**ARCHITECTURAL REVIEW BOARD
CITY OF FREDERICKSBURG, VIRGINIA
AGENDA
February 10, 2020
7:00 P.M.
COUNCIL CHAMBERS, CITY HALL**

TO: ARCHITECTURAL REVIEW BOARD
FROM: Kate Schwartz, Historic Resources Planner
DATE: February 5, 2020 (for the February 10, 2020 hearing)
SUBJECT: Certificate of Appropriateness for accessory structures at 303 Fauquier Street

TO: ARCHITECTURAL REVIEW BOARD
FROM: Kate Schwartz, Historic Resources Planner
DATE: February 5, 2020 (for the February 10, 2020 hearing)
SUBJECT: Certificate of Appropriateness for demolition/new construction at 1005 Sophia St.

WEST ELEVATION (Sophia Street)
January 17, 2020

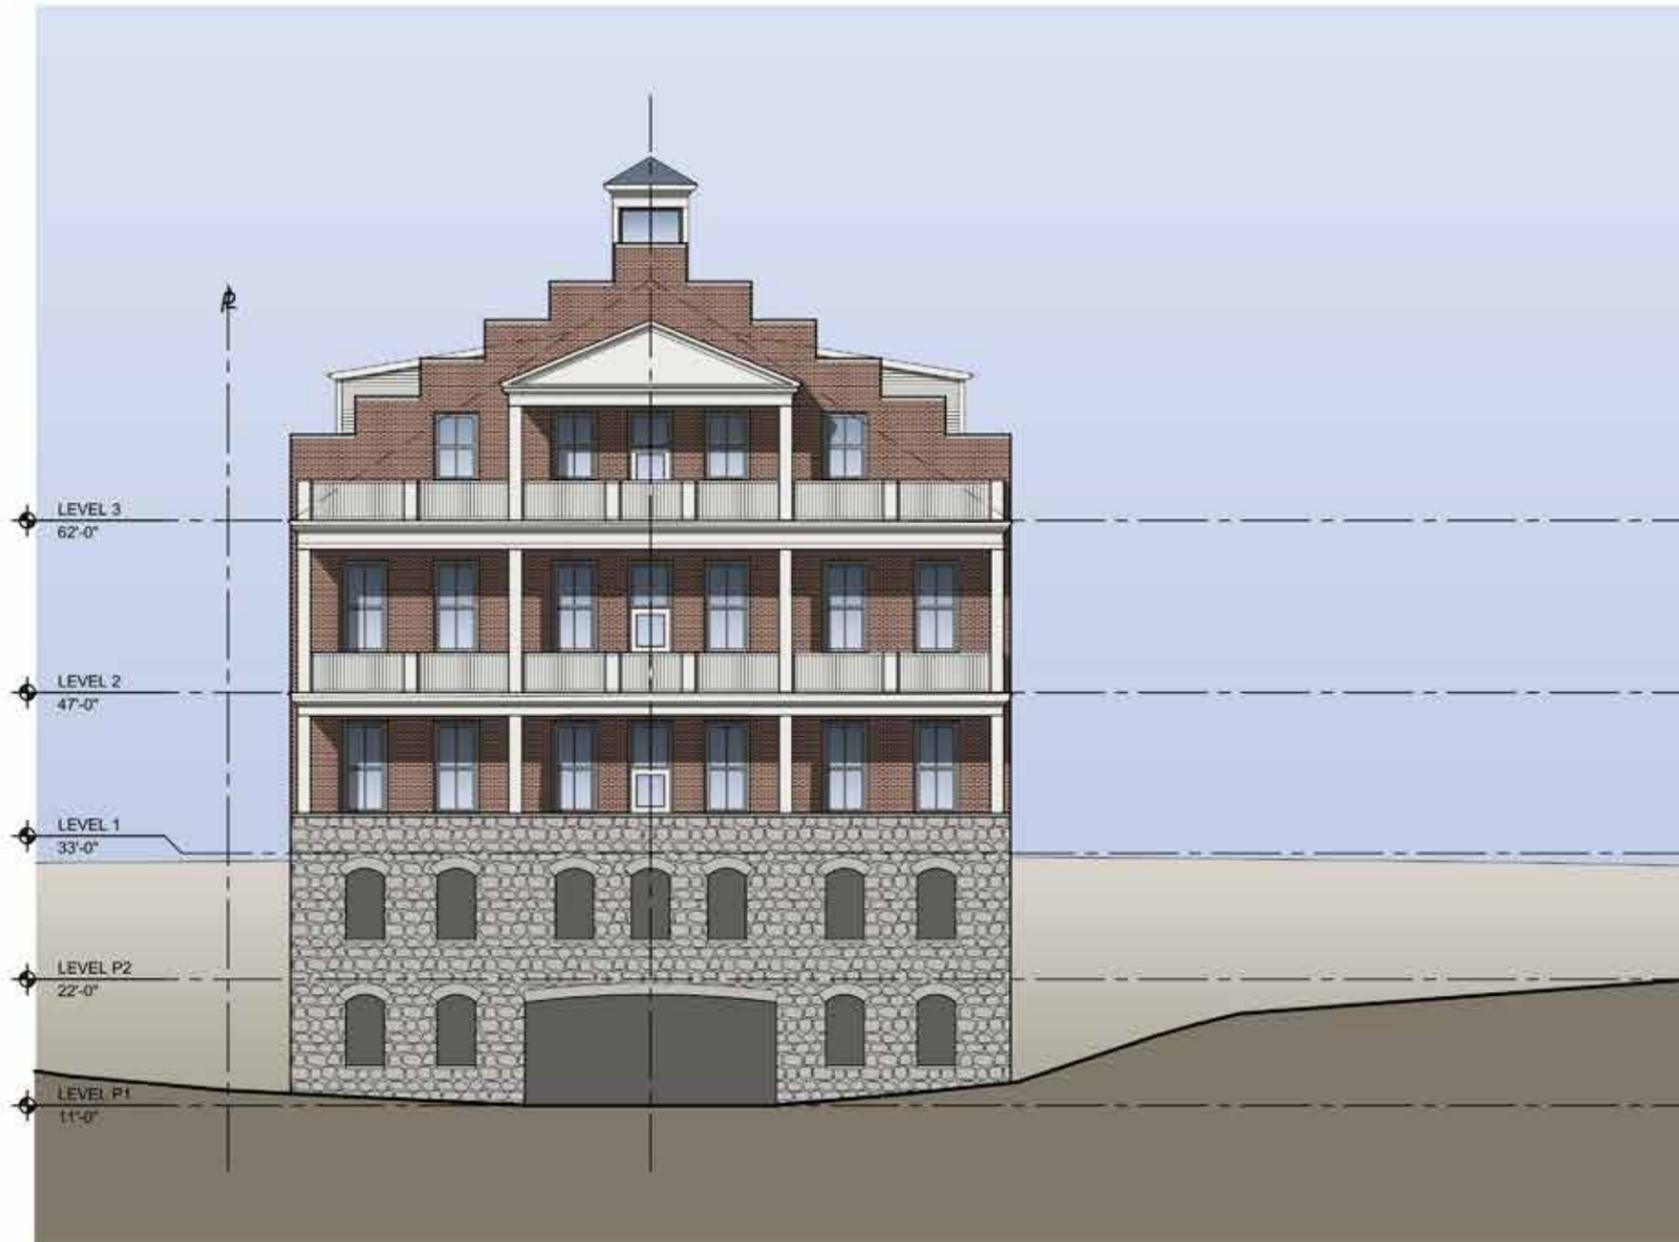
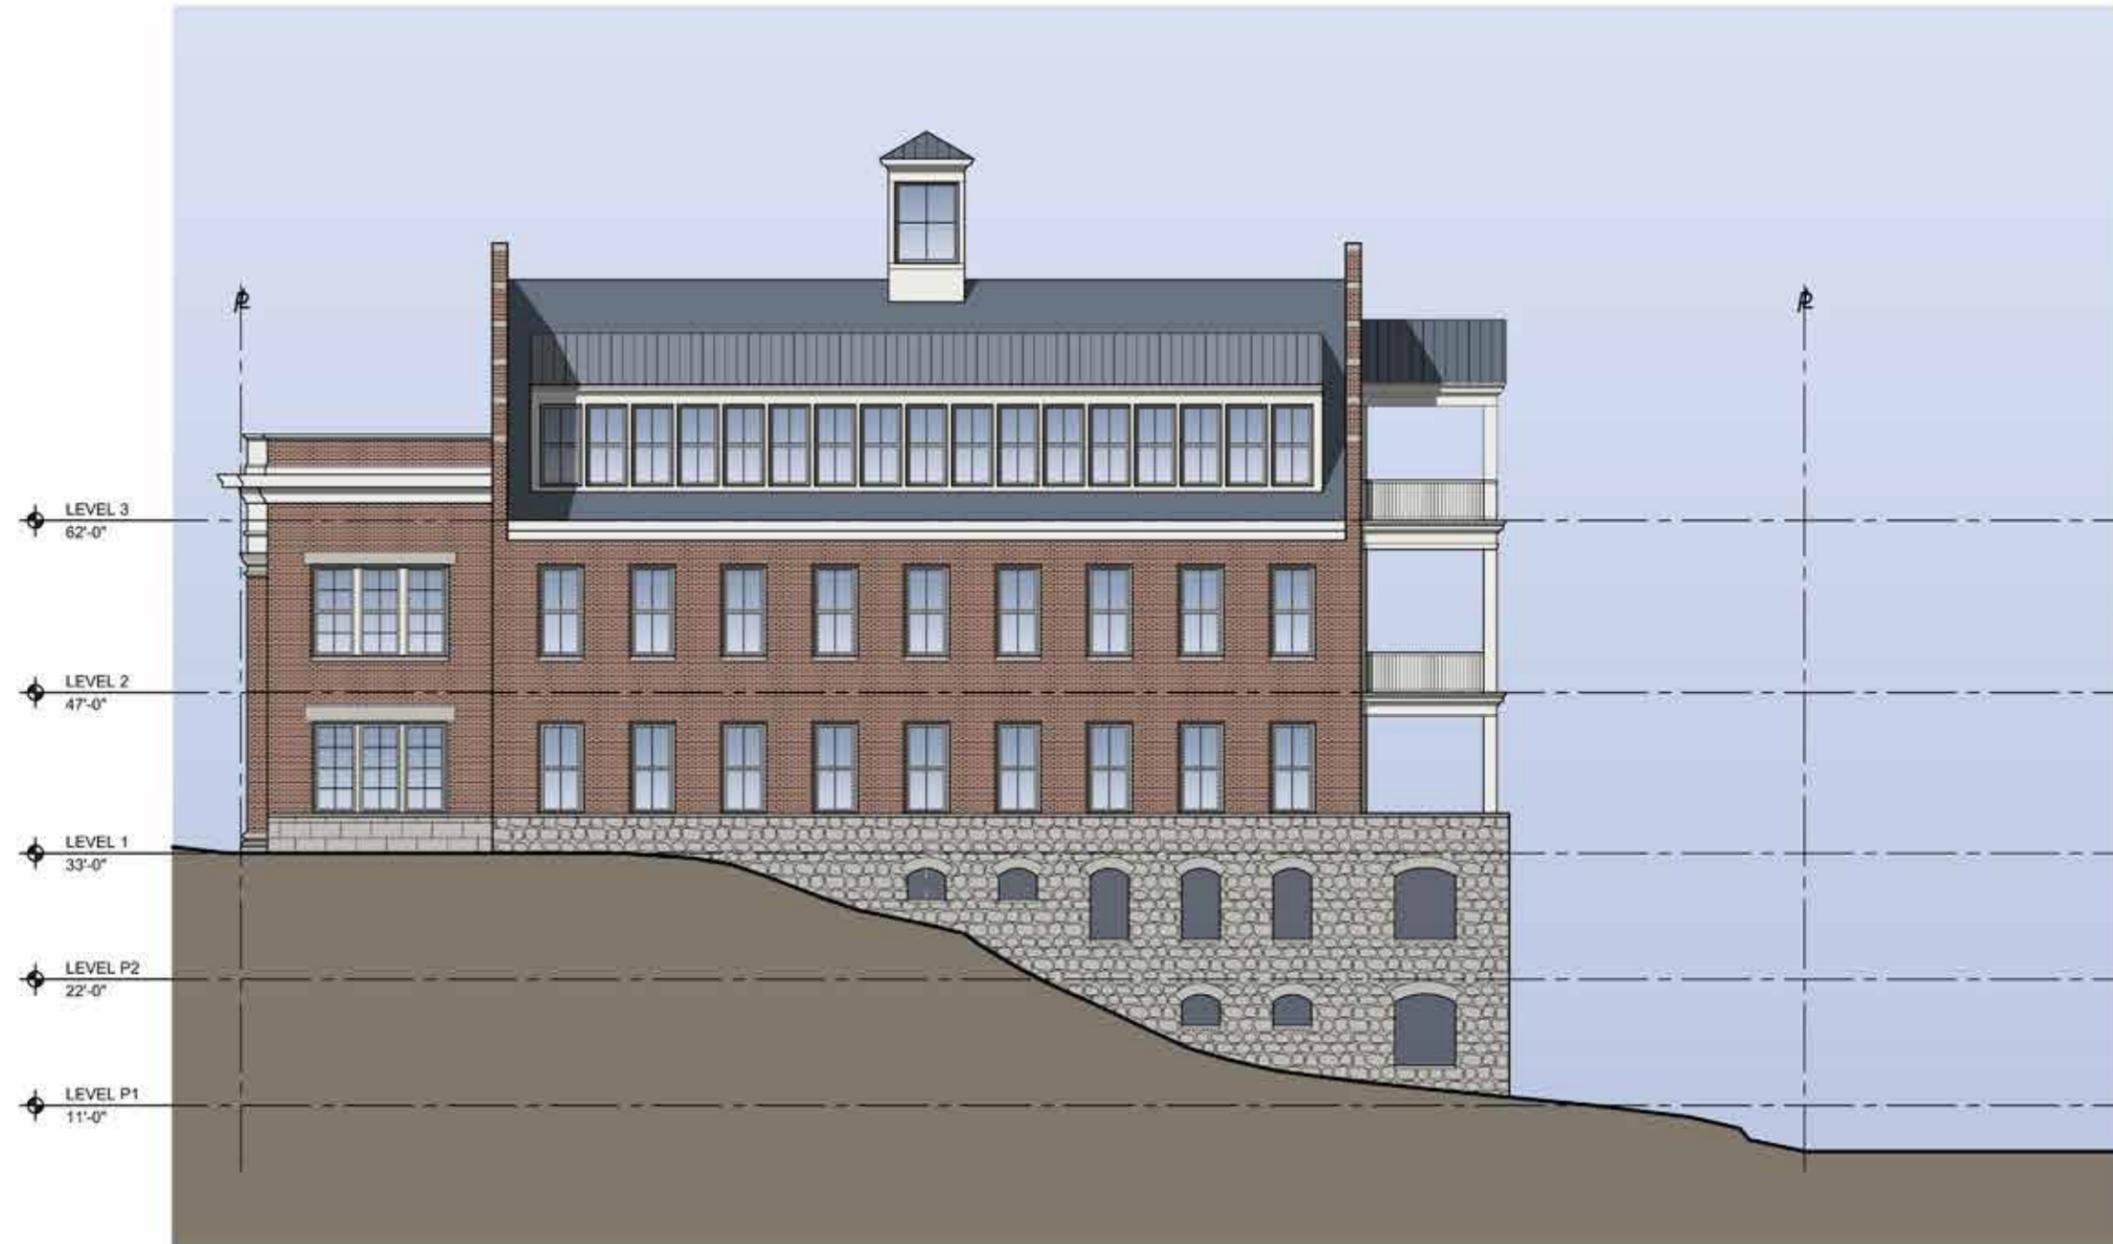
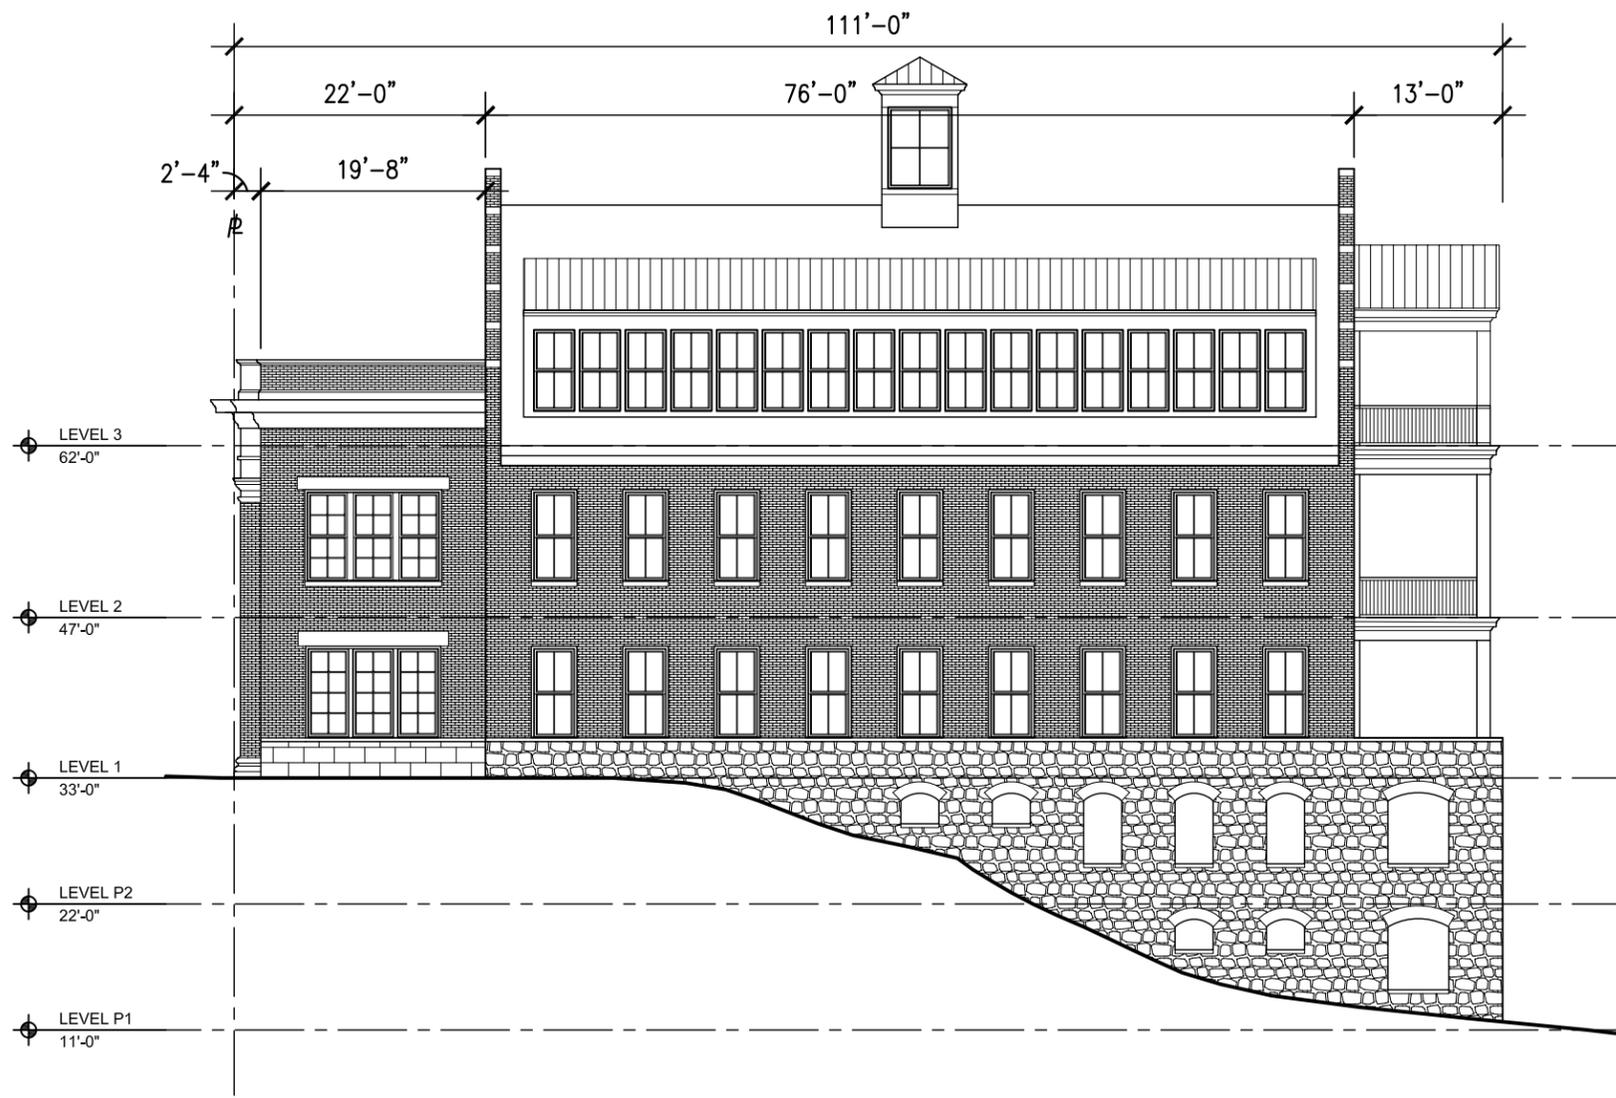
Approval of the site planning, scale, and massing of the new commercial building on condition that the floor heights, parapet height, or both are reduced to better align with the adjacent building across Sophia Street.

Approval of the site planning, scale, and massing of the project is recommended on condition that the floor heights, parapet height, or both are reduced on the two-story block at the street level to match the overall height of the building across the street.
